Project	IEEE 802.16 Broadband Wireless Access Working Group < http://ieee802.org/16 >
Title	MIB II Integration and MIB II Table
Date Submitted	2006-03-06
Source(s)	Joey Chou [mailto:joey.chou@intel.com] Intel Corporation 5000 W. Chandler Blvd. Chandler, AZ 85226
Re:	
Abstract	This contribution proposed the text for Section 9 of IEEE P802.16i WG draft.
Purpose	Adoption
Notice	This document has been prepared to assist IEEE 802.16. It is offered as a basis for discussion and is not binding on the contributing individual(s) or organization(s). The material in this document is subject to change in form and content after further study. The contributor(s) reserve(s) the right to add, amend or withdraw material contained herein.
Release	The contributor grants a free, irrevocable license to the IEEE to incorporate material contained in this contribution, and any modifications thereof, in the creation of an IEEE Standards publication; to copyright in the IEEE's name any IEEE Standards publication even though it may include portions of this contribution; and at the IEEE's sole discretion to permit others to reproduce in whole or in part the resulting IEEE Standards publication. The contributo

Figure 20= SS/MS DL Synchronization

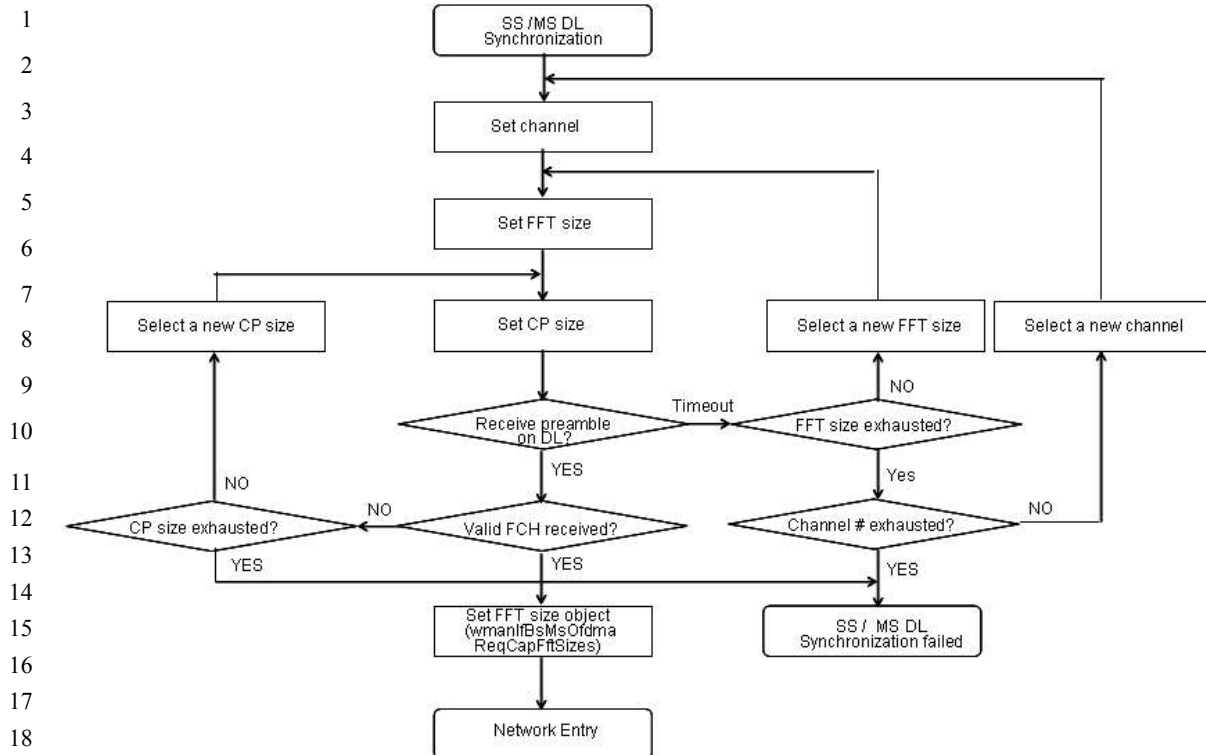
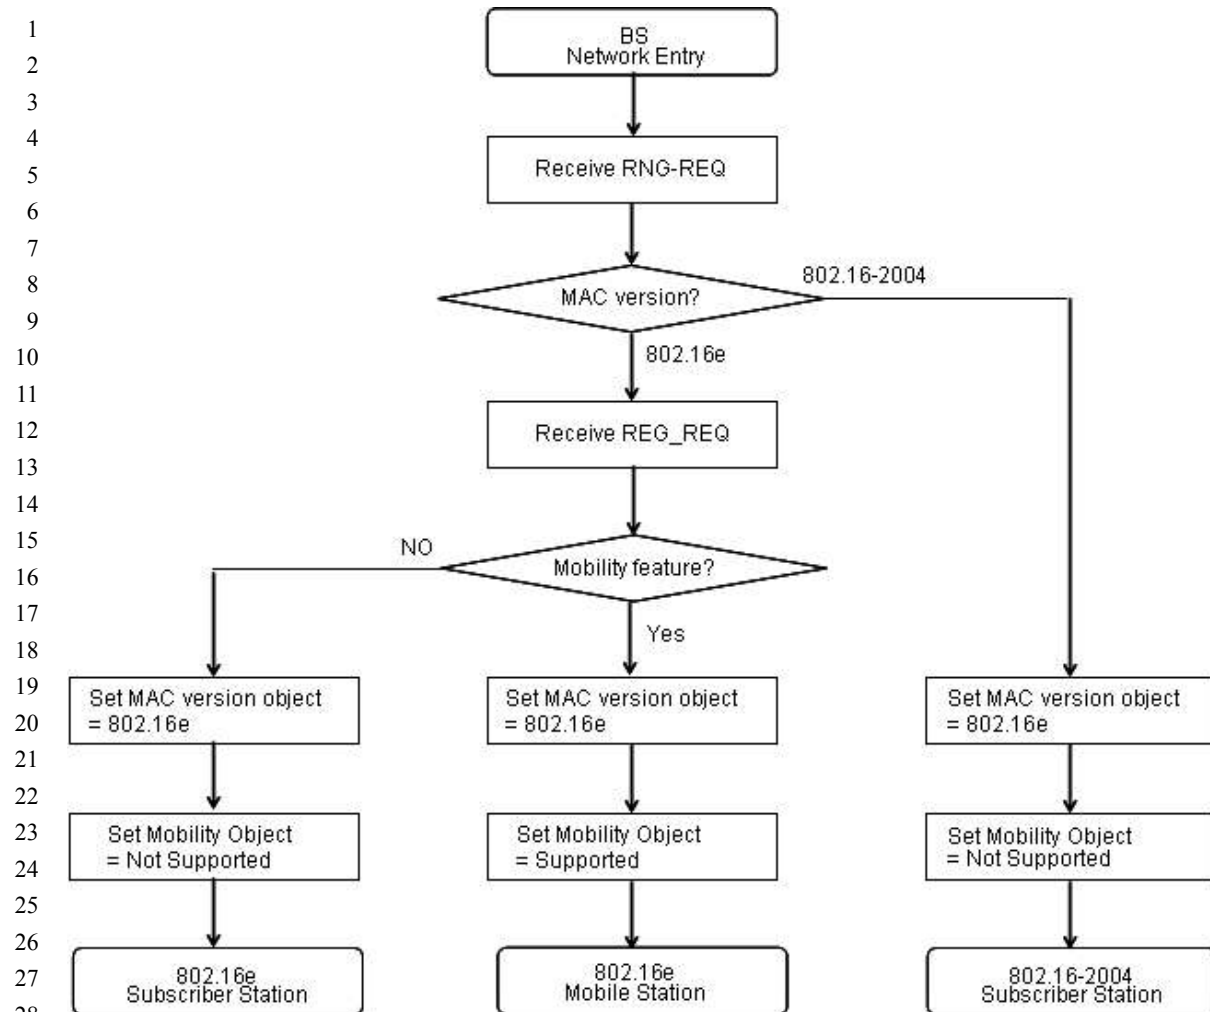
22 Figure 20 shows a procedure describing how BS can determine the FFT size of a SS or MS during
 23 the DL synchronization for.

- 22 1. Set the Rx channel (Select a frequency for receiving DL channel)
- 23 2. Set the FFT size
- 24 3. Set the CP size
- 25 4. If a preamble is received successfully, then go to step 5; otherwise,
- 26a. If FFT size is not exhausted, then select a new FFT size, and go to step 2; otherwise,
 - 27 ▪ If channel to be scanned is exhausted, then declare SS / MS DL synchronization
 - 28 failed; otherwise, select a new channel, and go step 1
- 29 5. Set the CP size
- 30 6. If a FCH (Frame Control Header) is received successfully, then go to network entry;
- 31 otherwise,
 - 32 a. If CP size is not exhausted, then select a new CP size, and go to step 3; otherwise,
 - 33 declare SS / MS DL synchronization failed
 - 34 b. Set FFT size object
